Service Bulletin

S.B. No: 157

FIVE-YEAR FUEL TANK INSPECTION

T67B, T67C Series, T67M, T67M-MkII, T67M200 and T67M260 (Pre and Post Mod M945).

FIGURE 3

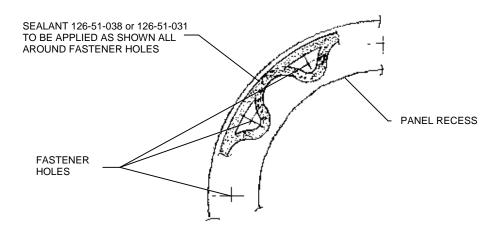
- 20.3 Check that panel sealant is in good order, if required paint with sealant 126-51-030.
 - 20.4 Refit access panel/s using sealant 126-51-038 or gasket sealant 126-51-031, applied IAW Figure 3. Ensure bonding strips are aligned. Use screws 126-21-116, fasten screw at bonding position first, and then diametrically opposite followed by remainder. Torque to 20-25 lb ins before sealant has cured as per previous sequence. Ensure continuous bead of sealant has formed around circumference of panel and that panel is flush or below surface. If below surface, ensure no more than 2mm. It is acceptable for sealant to ooze out at screw positions.

FIGURE 4

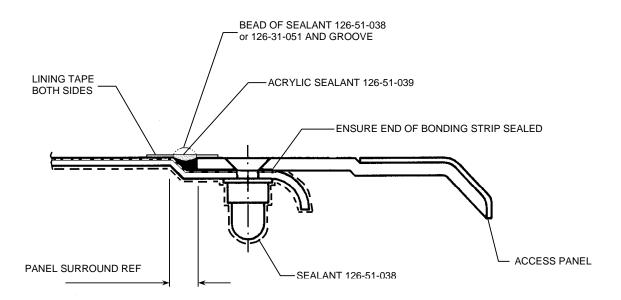
- 20 Replace the fuel filler access panel/s as follows:
 - 20.1 Check integrity of bonding strap, on the wing or fuselage and access panel.
 - 20.2 Check that the sealant around the anchor nuts is in good order repair by painting with sealant 126-51-038 use 30mm margin around any damage. Ensure end of bonding strip is sealed, refer Figure 4.

- 20.5 Using gloved finger remove bead of sealant (before cured), leaving a curved-bottomed groove. Allow sealant to cure, Figure 4 refers.
 - 20.6 After sealant has cured, replace filler cap and check tanks for pressure and perform bonding tests, (0.02 ohms or less), IAW relevant aircraft's Maintenance Manual. Rectify as required.

- 20.11 Once dry remove masking and using lining tape, line edge of groove. Ensure tape level. Refer Figure 4.
- 20.12 Fill groove to the level of the tape using acrylic sealant 126-51-039. Allow to cure.
